HISTORIC AND DESIGN REVIEW COMMISSION

August 03, 2022

HDRC CASE NO: 2022-303
ADDRESS: 226 E HUISACHE AVE
LEGAL DESCRIPTION: NCB 3086 BLK 2 LOT 7
ZONING: R-4 CD, H
CITY COUNCIL DIST.: 1
DISTRICT: Monte Vista Historic District
APPLICANT: Nadav Givoni/GR-226 HUISACHE LLC
OWNER: Nadav Givoni/GR-226 HUISACHE LLC
TYPE OF WORK: Window replacement
APPLICATION RECEIVED: May 01, 2022
60-DAY REVIEW: Not applicable due to City Council Emergency Orders
CASE MANAGER: Hannah Leighner
REQUEST:

The applicant is requesting a Certificate of Appropriateness for approval to replace nineteen (19) existing wood windows with new wood windows.

2 SOUTH ELEVATION
SCALE 1/4"=1'-0"

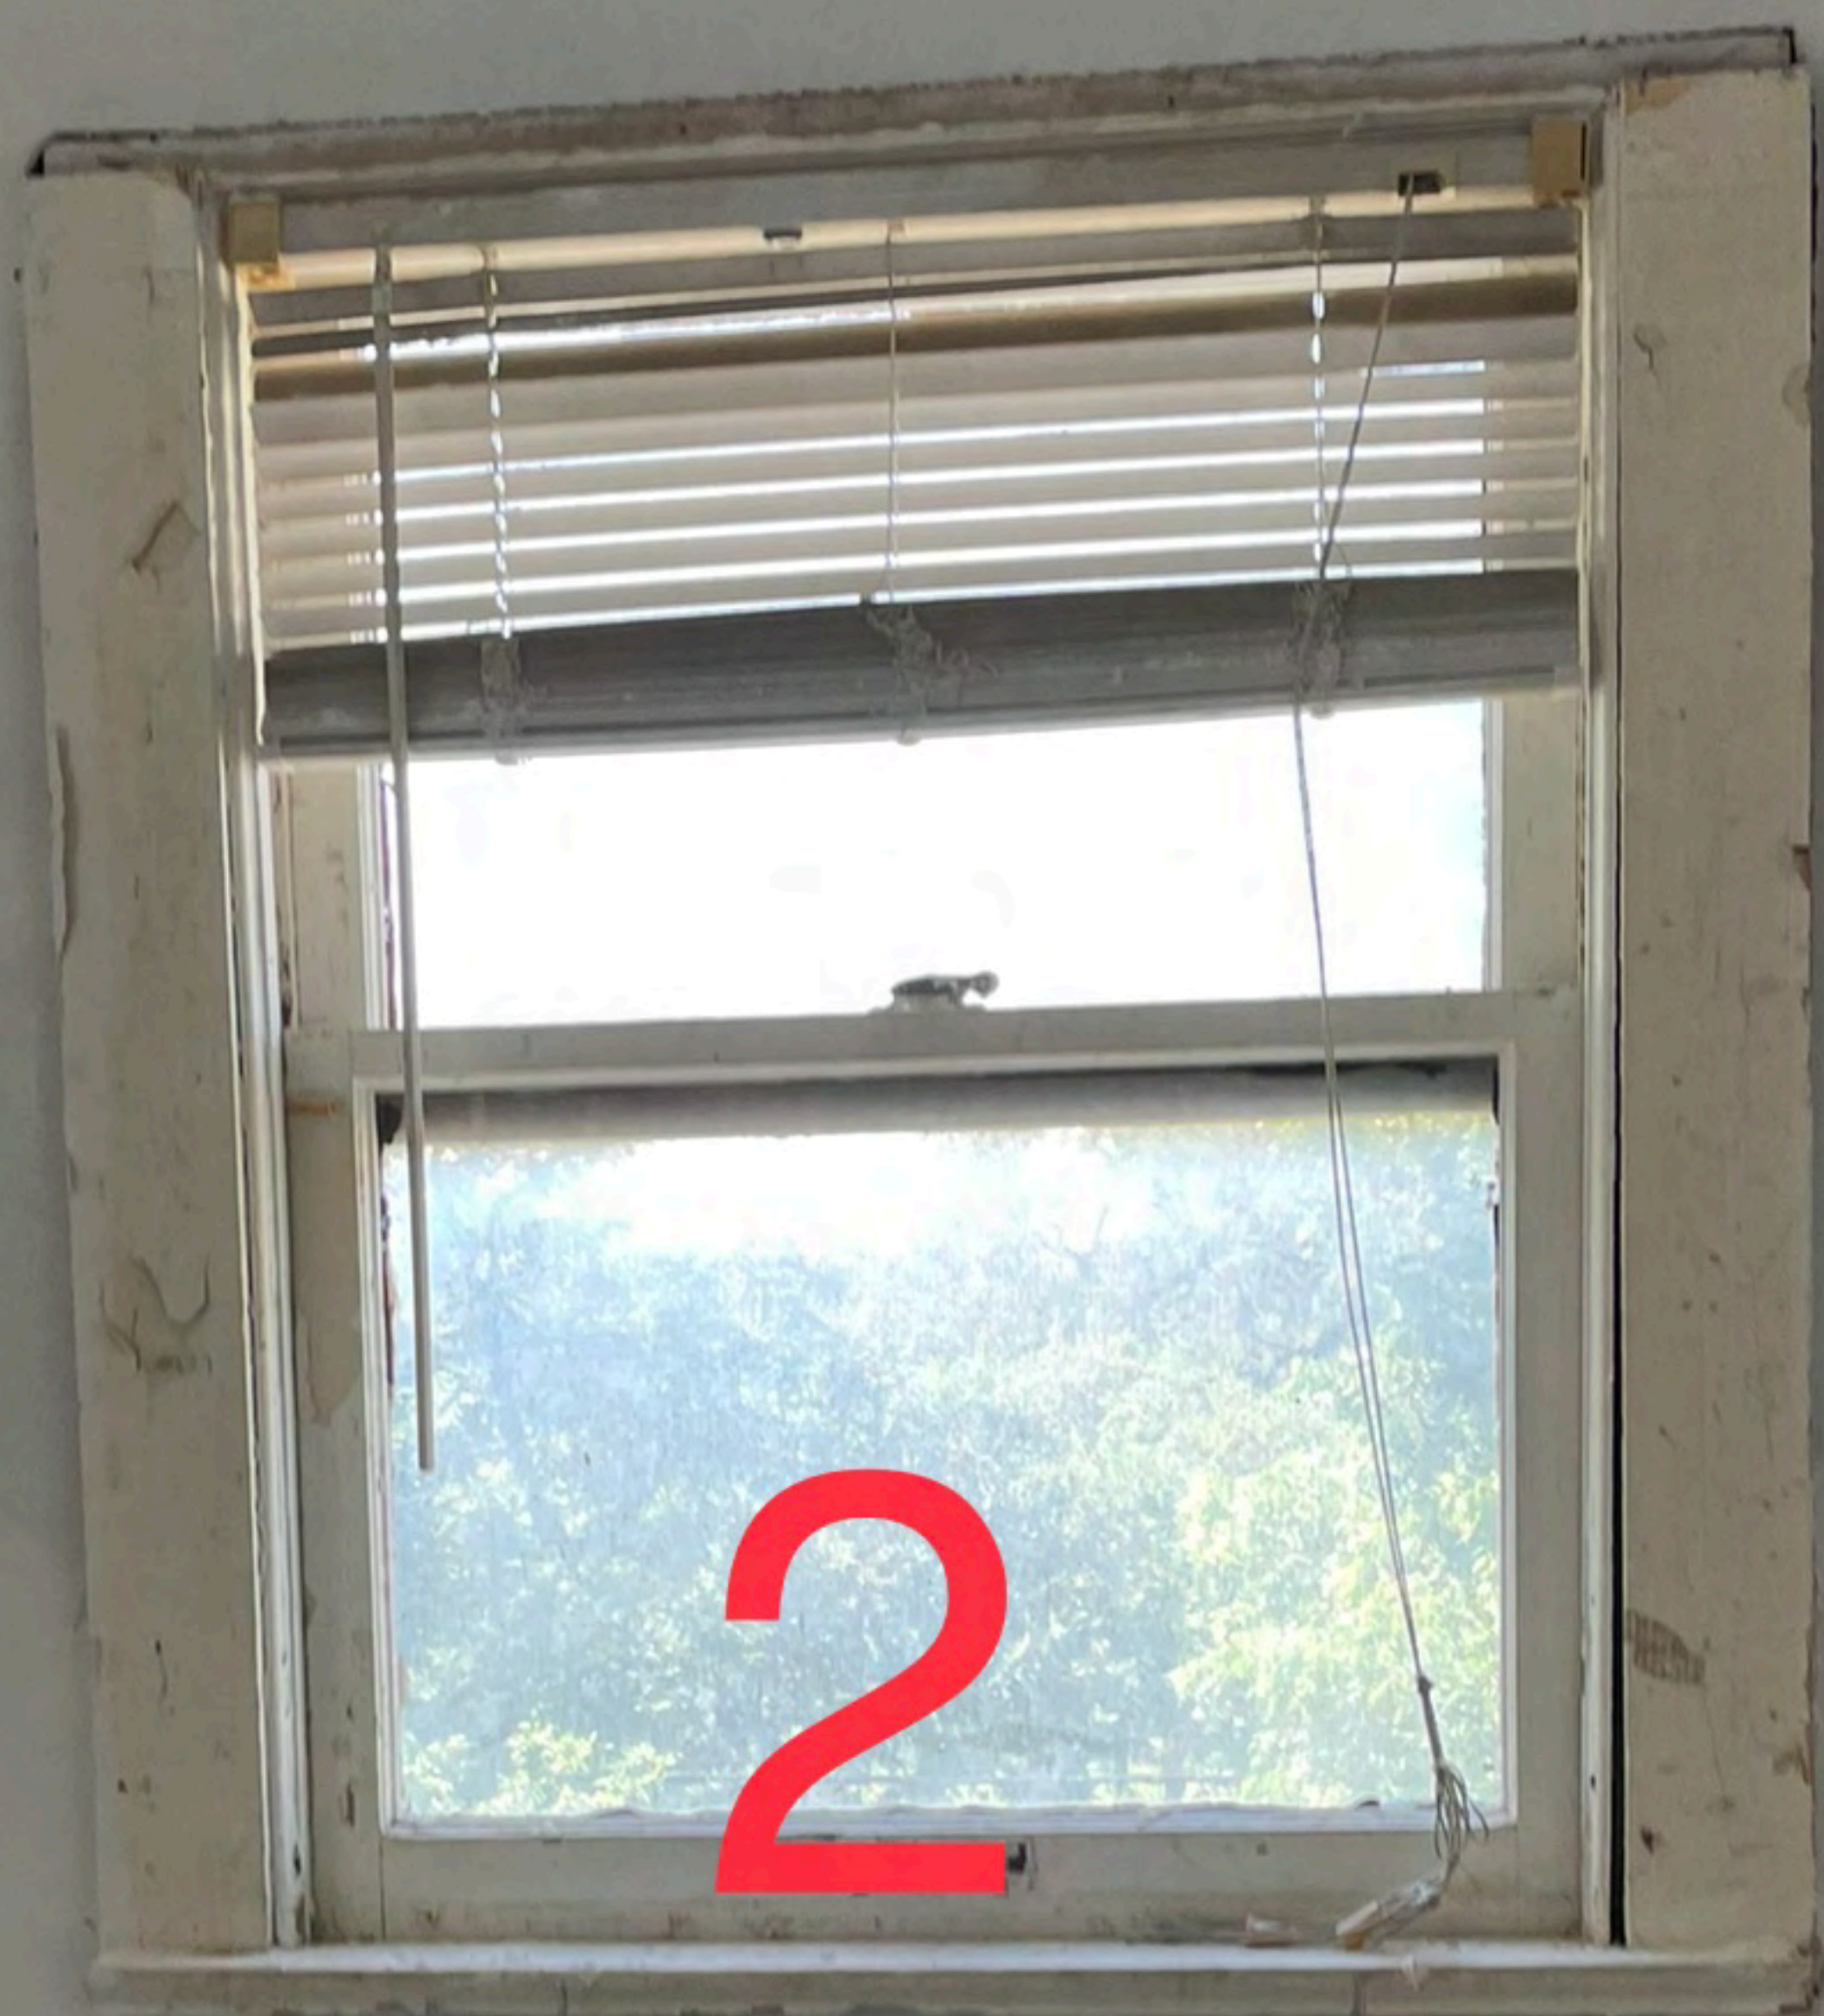
The current condition of the windows is such that many are unrepairable. I've had multiple contractors visit the site and have commented as such. I need to replace them with comparable Marvin windows that are approved for historic window replacement.
